Portugal Street East
The Fairfax
Design Justification Statement

This brochure presents a set of amendments to the Portugal Street East development (now to be called The Fairfax) that are required to ensure technical and legislative compliance in the period from initial design and submission of the planning application in October 2018 to delivery in 2022.

This updated document is being presented to Manchester City Council Planning Department to illustrate and explain the nature and extent of the proposed changes accommodated following feedback from MCC and to seek the Council's formal approval through the necessary planning process.

DRAWING NO:
_MP_02_2199

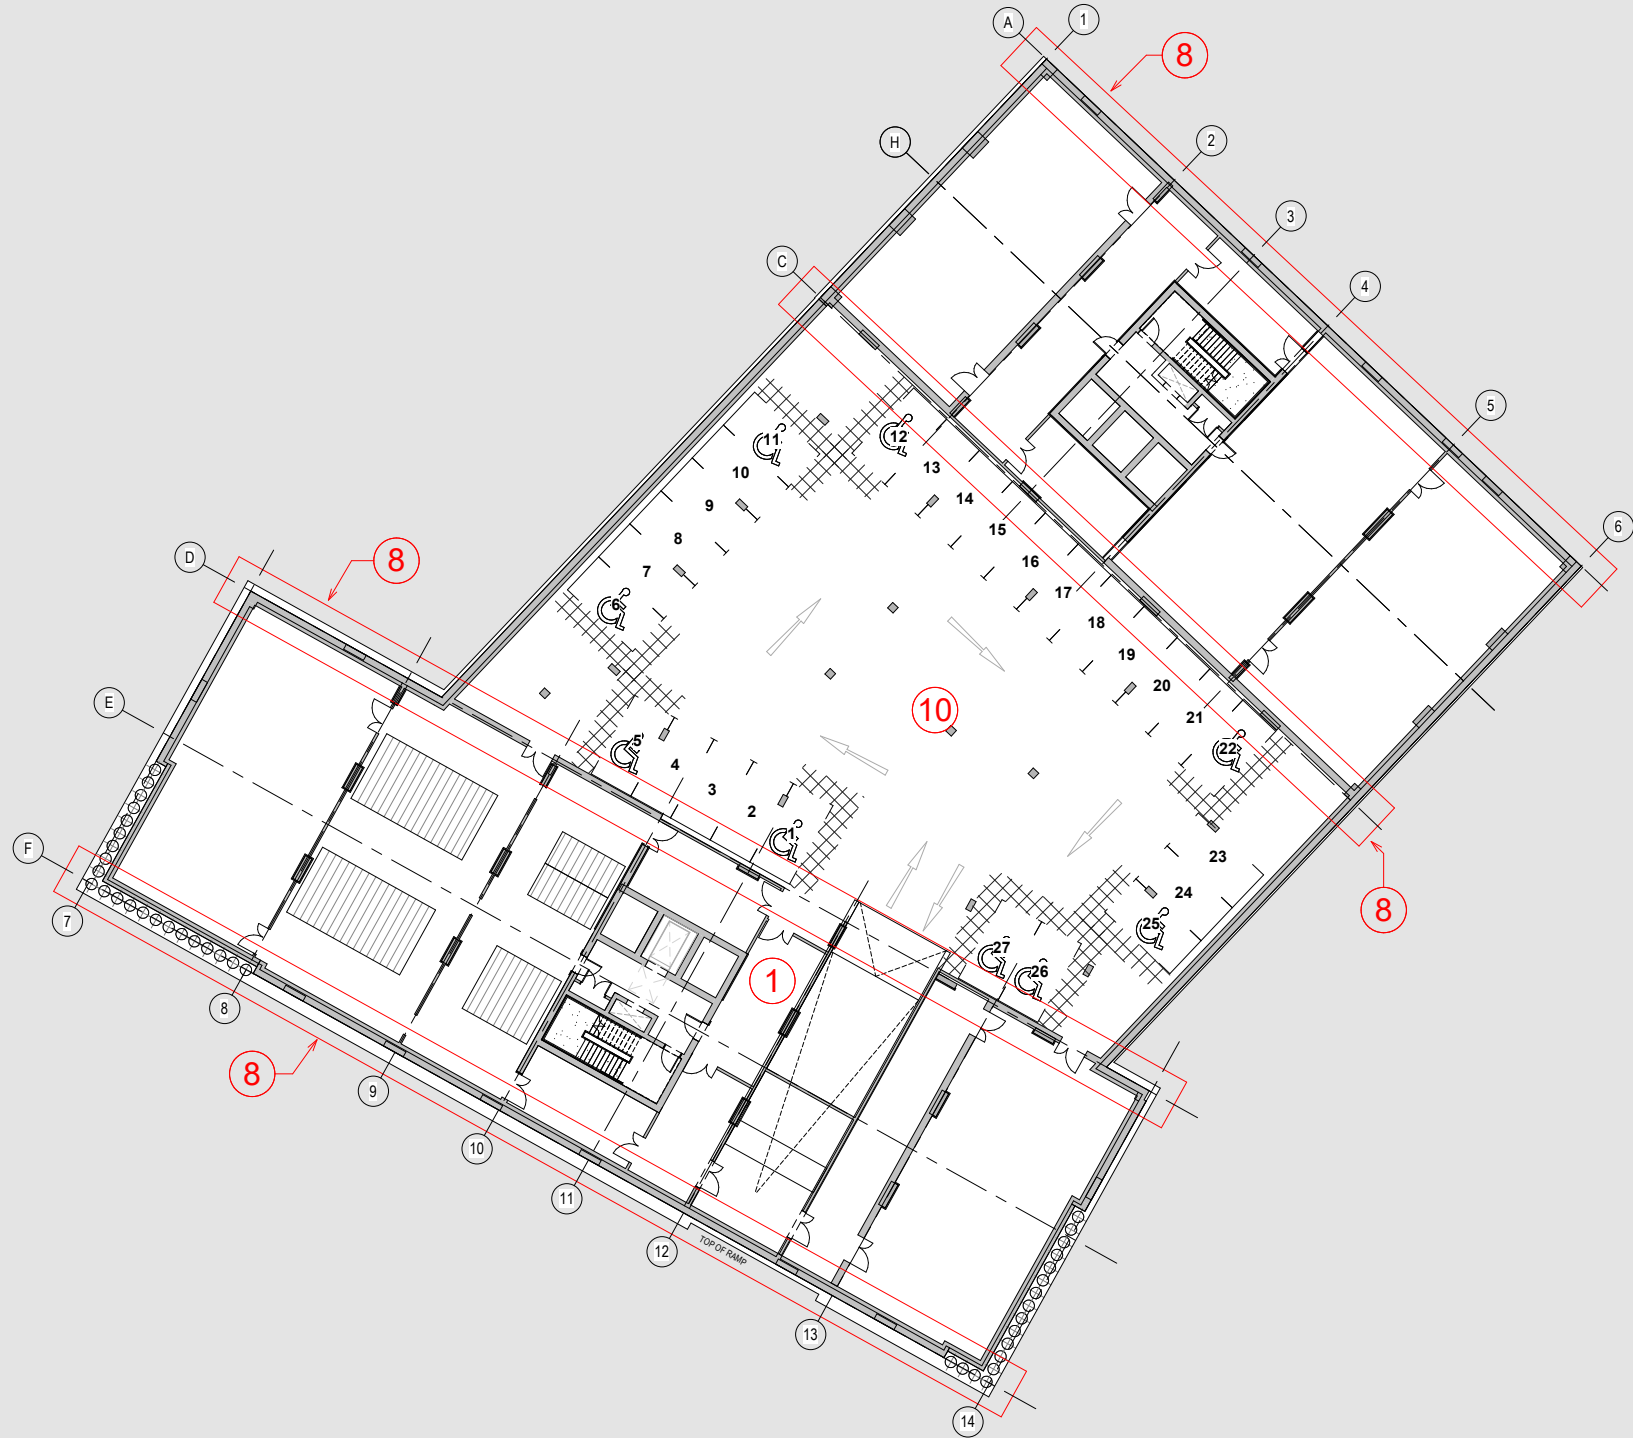
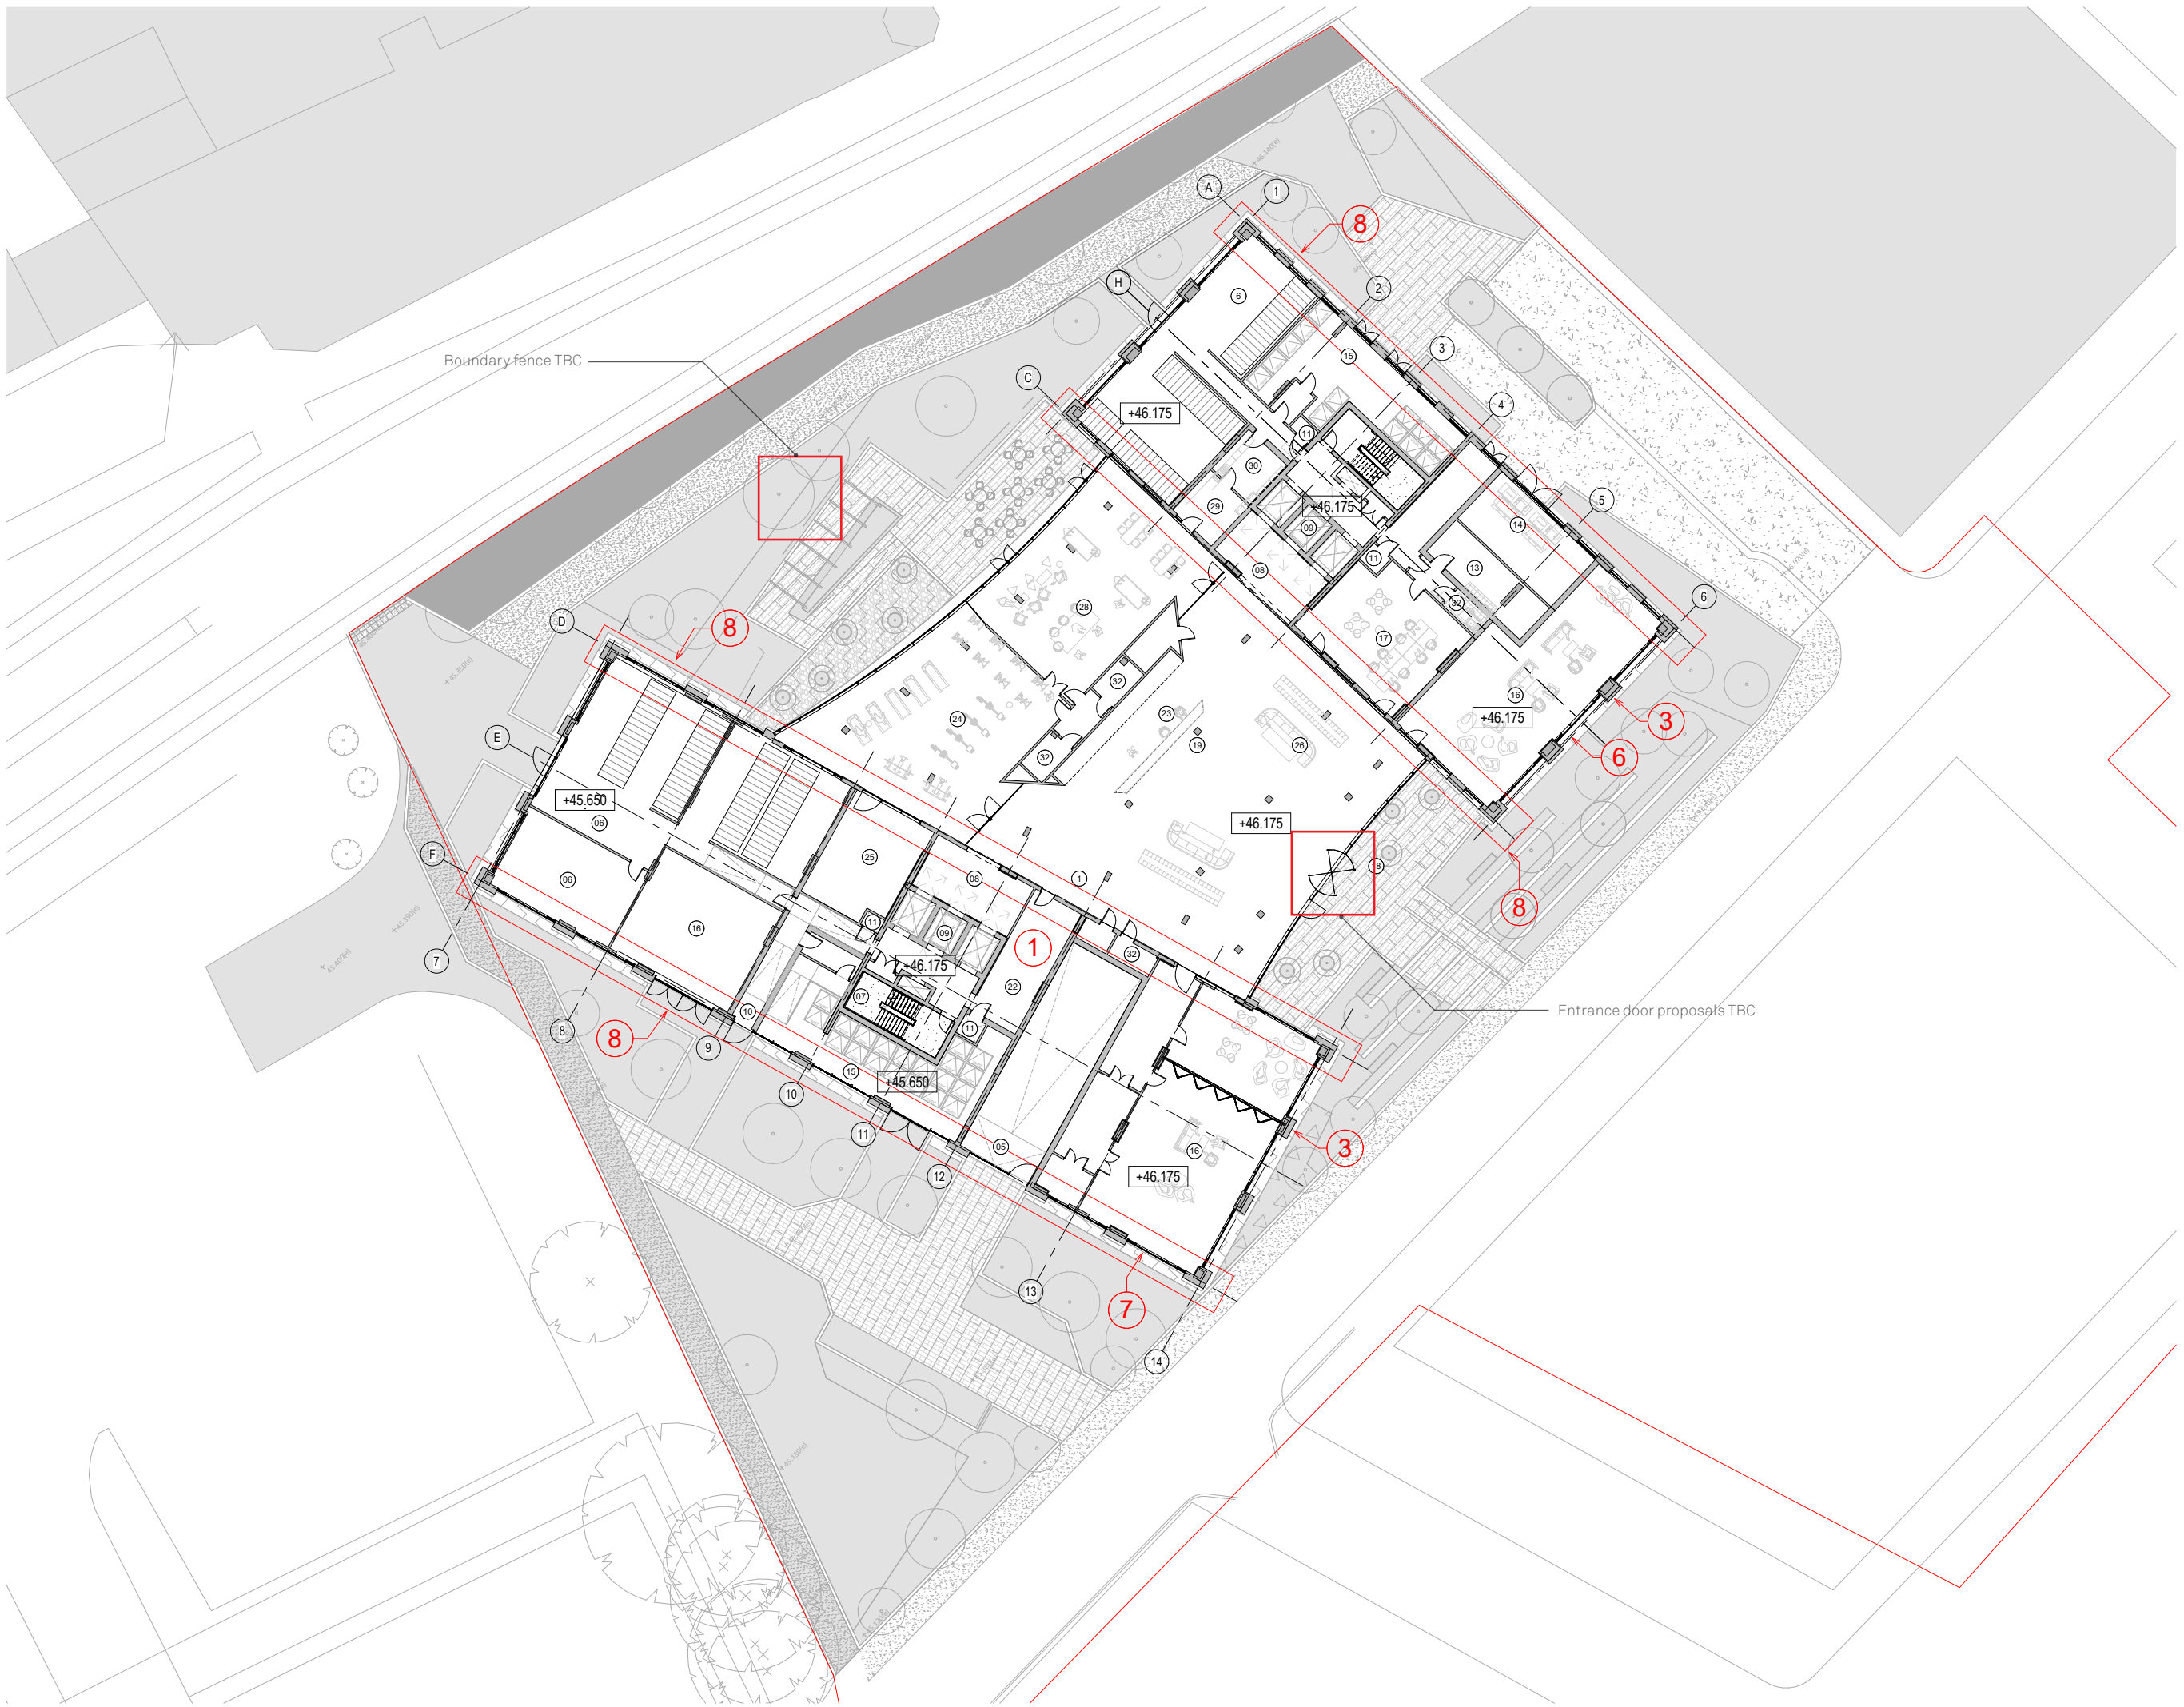
No.	Location	Change	Reason	approved drawing	proposed drawing
1	Basement Floor & Ground Floor	Concerige lift omitted	No longer required.	_MP_02_2199 _MP_02_2200 _B2_02_2200 _B1_04_2200 _B2_04_2201 MP_04_2201 MP_04_2202 B3_05_1201 B3_05_1202 MP_05_1201	20-0101, 20-0102, 20-0109, 20-0114 20-0201, 20-0202, 20-0203, 20-0204, 20- 0205, 20-0206,
2	Basement to Ground Floor & Ground to First Floor	Floor level and floor to floor dimension amended	The floor to floor dimensions have been changed to suit brick course dimensions to improve buildability and detail as the approved drawings didn't course. Basement FFL raised by 15mm and Ground Floor FFL raised by 40mm but all other upper floor levels remain the same. Block 2 parapet height raised by 50mm to suit brick course dimensions to improve buildability and provide 1100mm high parapets for safety purposes following technical development of roof build-up.

PROJECT	DRAWN BY	CHECKED BY
1284-21	MG	MH
ROLE	NUMBER	REVISION
A	20-0103	E

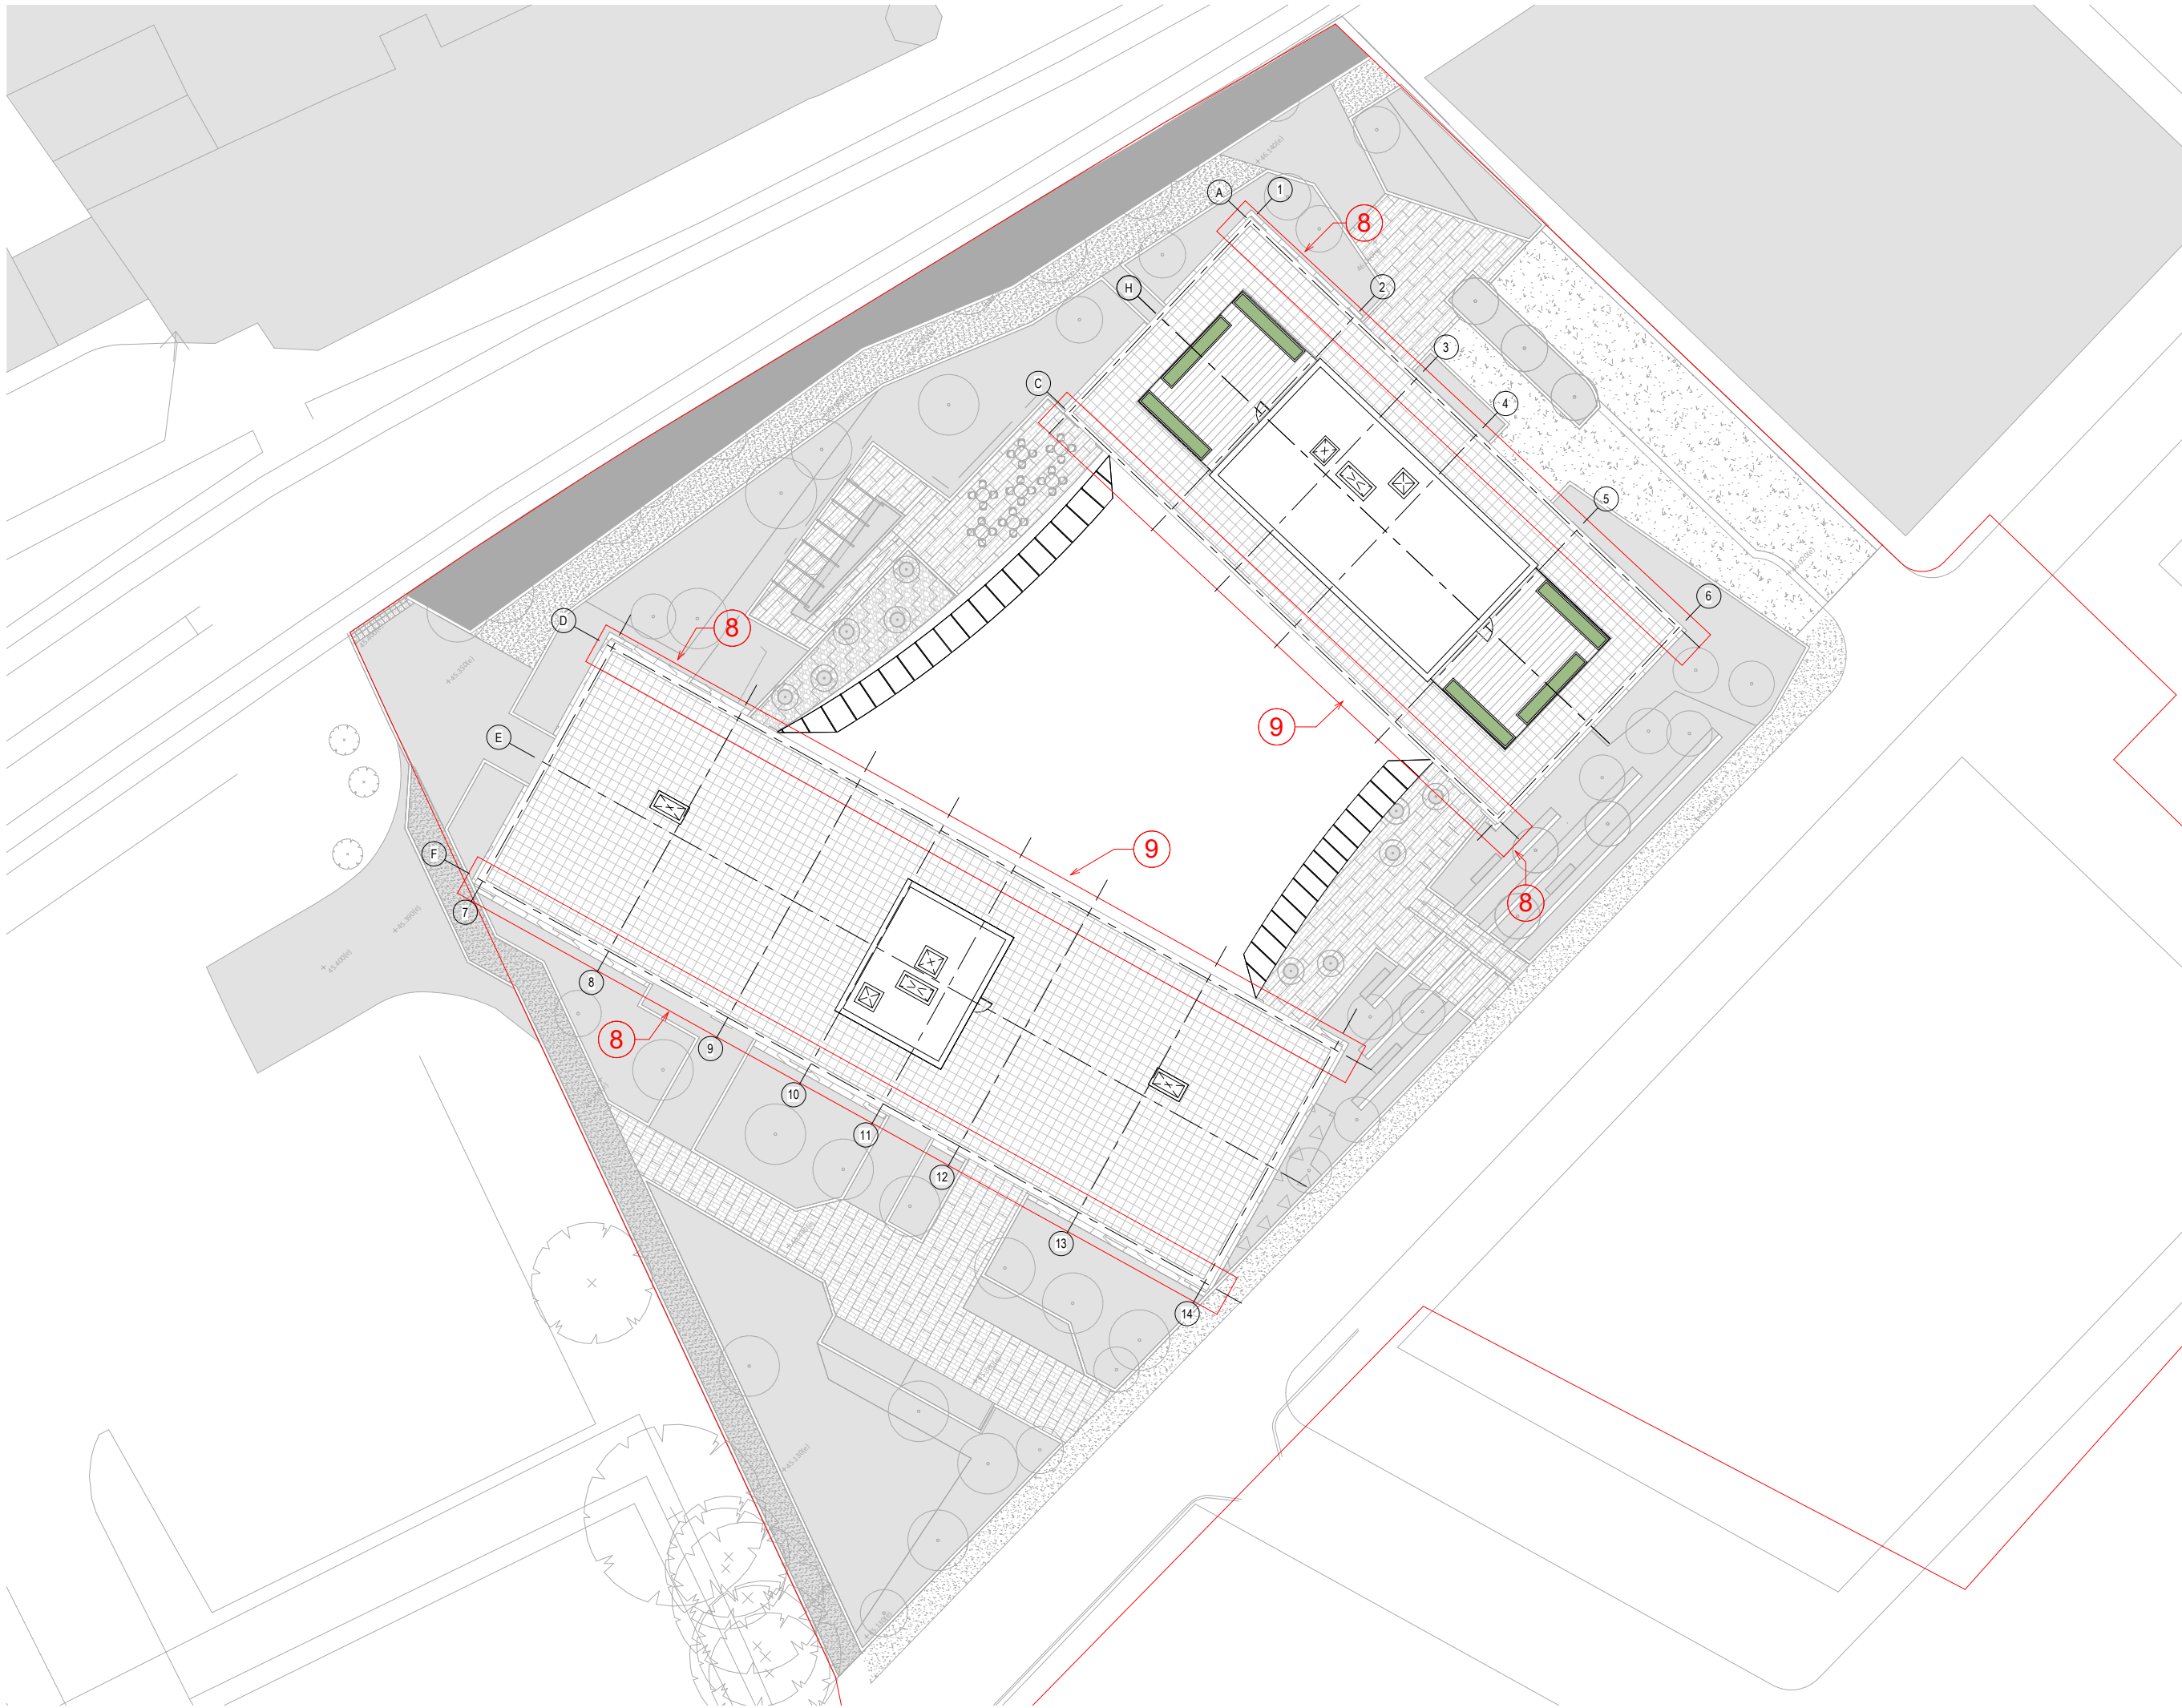
9	Block 3 roof design	Glazed banding omitted from Block 3 roof along interfaces with building facades (other glazed roof areas to remain)	The glazed strips have been changed to a solid roof construction (green roof) due to issues around fire spread from glazed roof areas to glazed areas on the building facades. Improves long term maintenance strategy. Improves privacy for residents.	_MP_00_1201 _MP_02_2230 _B1_02_2201 _B2_02_2201 _B3_02_2201	20-0103 & 20-0115
10	Basement car park layout	Basement car park layout amended	Car park layout has been amended to increase number of accessible car parking spaces. Total number of car park spaces remains unchanged. Amendment in response to condition 26.	_B2_02_2200 _B2_04_2201	20-0109 & 20-0205
11	Generator flue	250mm diameter metal flue added to Block 2 South West elevation	External generator flue required to be added to plant space elevation at ground floor for service reasons. Flue to project 300mm from external façade and located within plant room louvres. Flue to be coloured matched to the louvres. The generator is required as part of the life safety fire strategy to provide a secondary power supply should this ever be required.	_B2_02_2200 _B2_04_2201	20-0109 & 20-0205
